SC-8229

THEODOSIA 1.3km

2019 Inspection

Approach from Right Bank when facing downstream

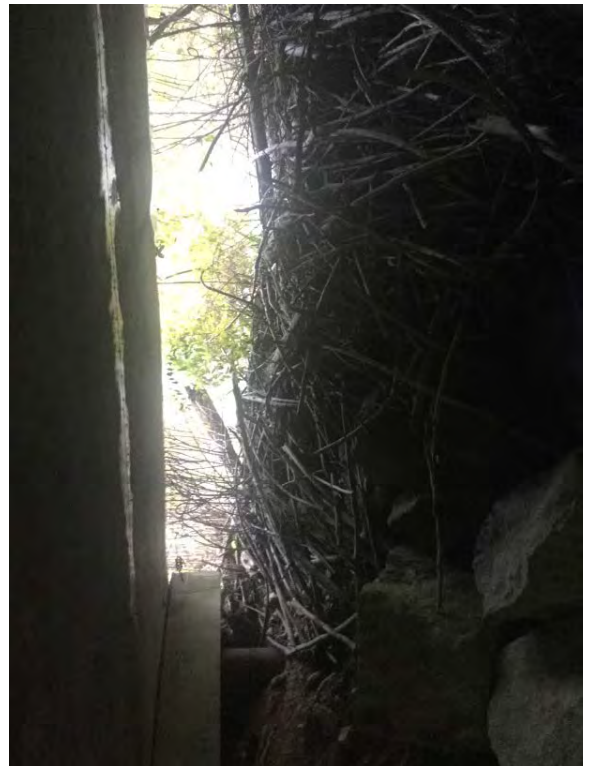
Guard Rail

Approach Barrier

| 2 | Low  | Re- set no post barriers. Add delineators |
| 3 | High | Replace guardrails                        |
